ADDENDUM No. 1

Project Name Waller - Eastwoods Park Stream Restoration

C.I.P. No. 5848.066

WALLER CREEK - EASTWOODS PARK
STREAM RESTORATION
PLAN DETAILS

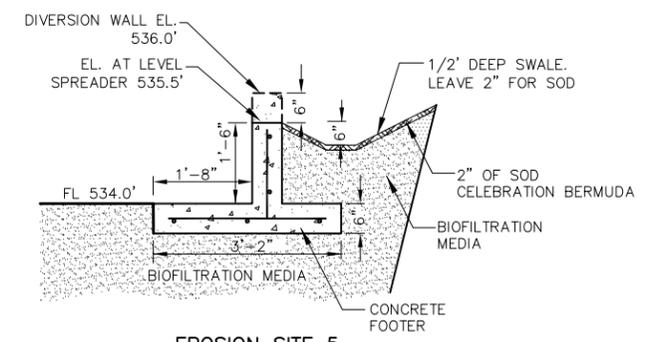
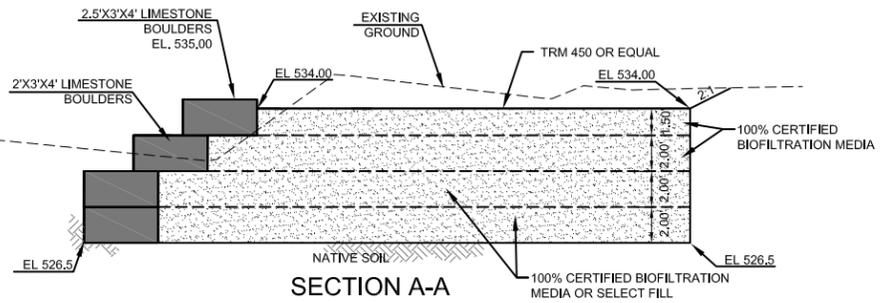
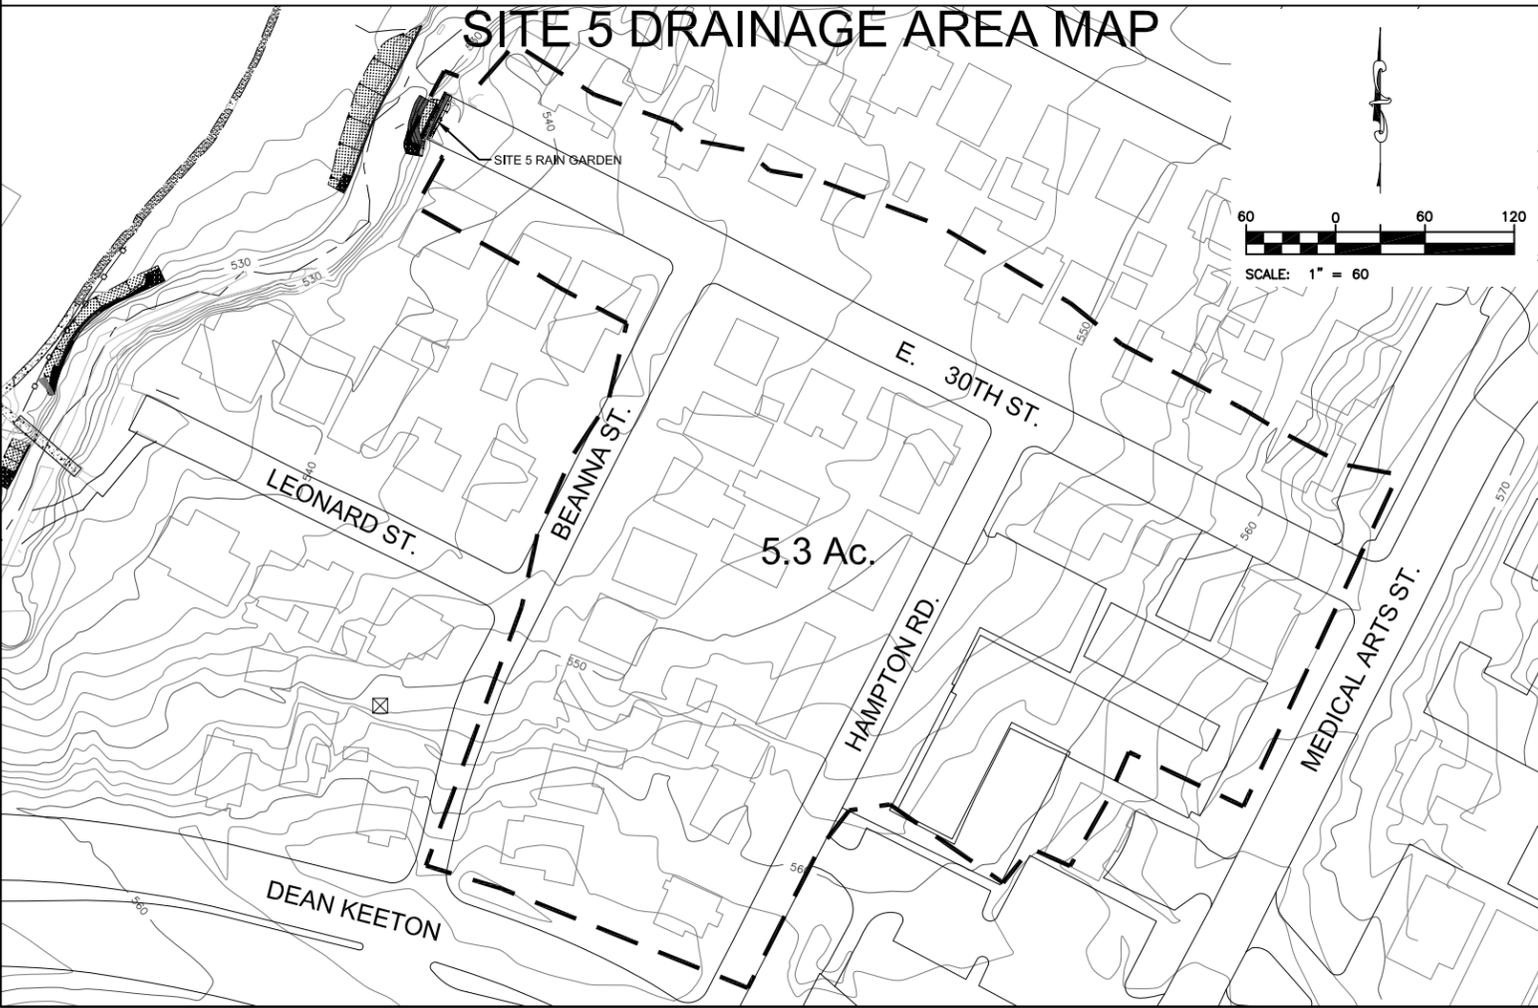
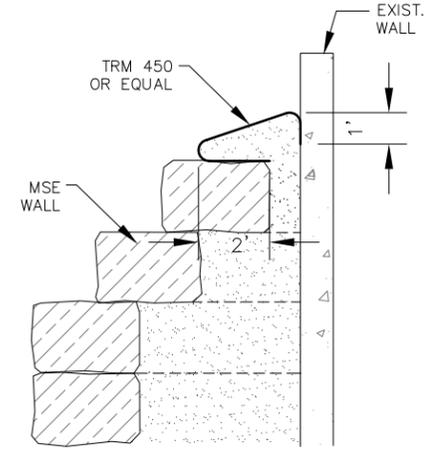
NO.	BY	DATE	DESCRIPTION
1	ADD 1		Final biofiltration boulders
